COUNCIL ASSESSMENT REPORT

SYDNEY NORTH PLANNING PANEL

| PANEL REFERENCE & DA NUMBER | PPSSNH-283 - DA/484/2011/K |
| PROPOSAL | Section 4.56 modification to Villas 26 to 46 to change villa layouts, amend internal driveway areas and amend community center design. |

Figure 4: Proposed amended Layout to Stage 2 in pink. Note two units relocated to access off internal service road and decreased side setback.

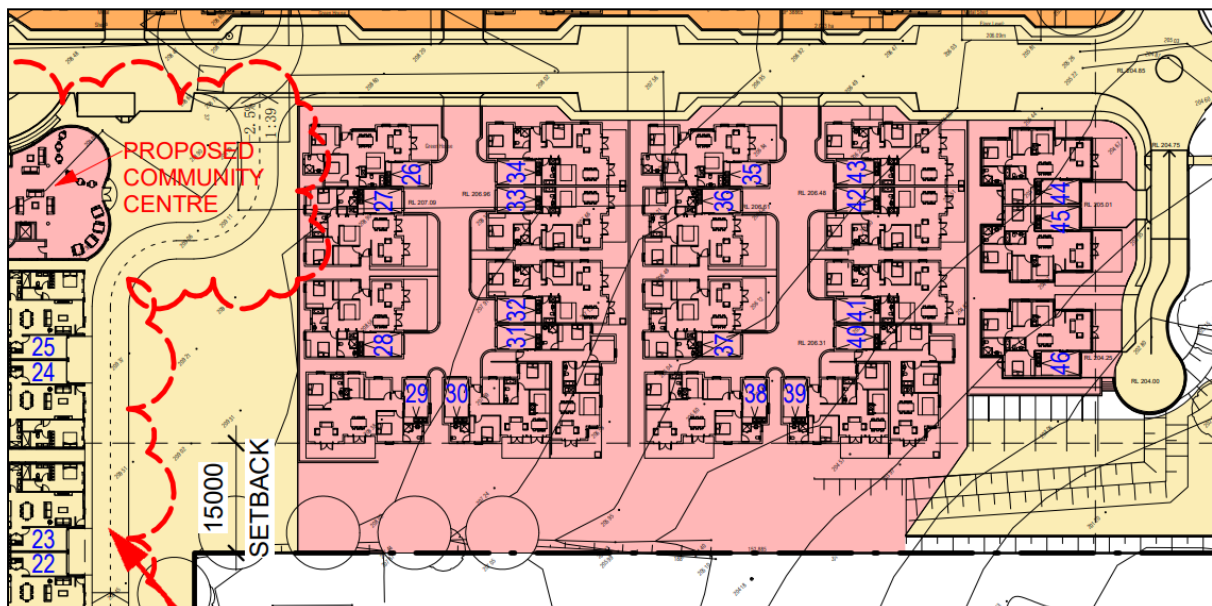
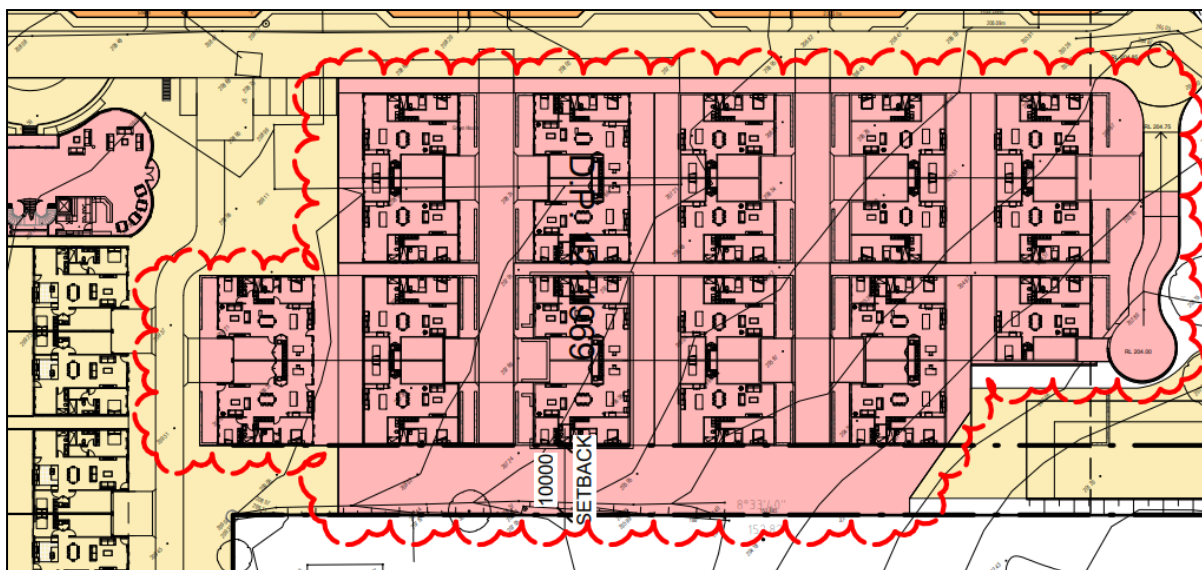
The proposed modifications to the Stage 2 dwellings would result in a decreased side setback from 15m to 10m. This will lead to a subsequent reduction of the landscaped buffer along the eastern boundary as shown in Figure 6. The landscaped area adjoining the eastern boundary currently comprises of a landscaped garden area and a vegetated drainage swale as shown in Figure 5 below.

Comment: The proposed development would decrease the side setback to the eastern side boundary with 290 Galston Road from 15 to 10 metres. The Hornsby Development Control Plan 2013 prescribes a minimum side setback distance of 10 metres. Consequently the application retains compliance.

Figure 6: Proposed Landscape plan. Drainage swale highlighted in yellow for clarity

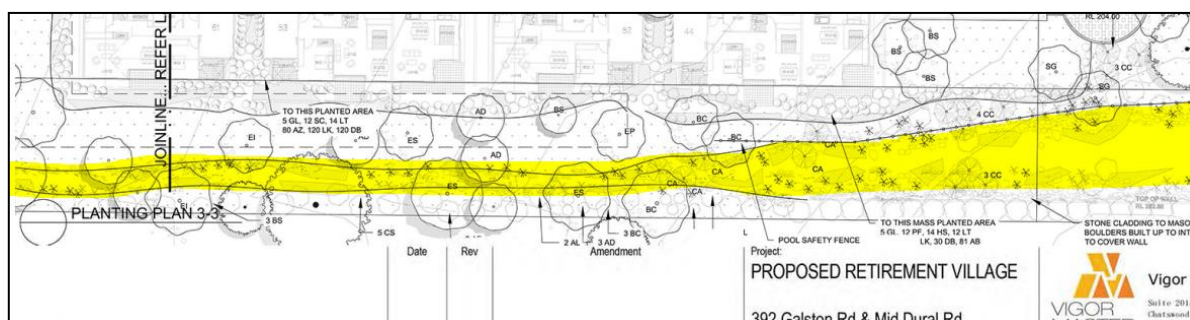
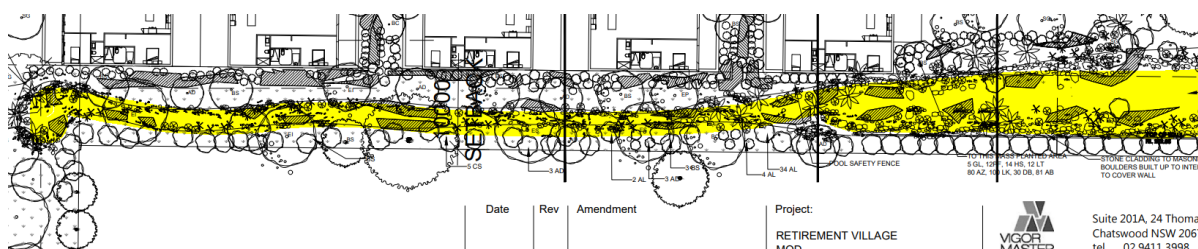
As indicated in Figure 6 above, additional planting has been proposed within the setback area.

- *There is no explanation included to explain or demonstrate how the visual separation required is achieved.*
- *The additional plant number provided do not cover all of the plant symbols on the plan and many relating to screen planting are missing*
- *The majority of the screen plants included are AL Acacia Longifolia (wattle) and AD Acacia falcata. Wattles are a fast growing natives that do not provide dense screening and are often short lived (up to 15 years) when most die out. To ensure sufficient screening more long-lasting dense screen plants should be used. I also note that these have only be provided at 200mm pot size and will low and of minimal screening when first planted.*

The applicant seeks to reduce the side setback distance from 15m to 10m. This reduces the area available in the side setback for screening landscaping. The eastern side setback area hosts a drainage swale which further reduces the area available for substantial sized landscaping. Council's landscape architect has reviewed the proposed amendments and has recommended that the landscape plan be amended to identify all proposed plantings, and that further screening plants be provided in the setback area.

To ensure that the amended landscaping within the eastern side setback achieves visual separation and a vegetated buffer between the subject site and adjoining rural development, the approved landscape Planting Plan, plan No. L04, prepared by Vigor Master dated 28.03.2022 is to be updated as follows:

- a) All plants indicated on the landscaping plan are to be clearly labelled with species and number; and
- b) The following additional planting are to be provided in the area marked in Red on the approved landscape plan
 - i) 50 x 45litre Syzigium cascade SC at 3m centres
 - ii) 30 x 25 litre Elaeocarpus reticulatus ER at 5m centres
 - iii) 15 x 25 litre Angophora costata AC at 10m centres
- c) The amended landscaping plans must be provided to the Principal Certifying Authority prior to the issue of a Construction Certificate for Stage 2.
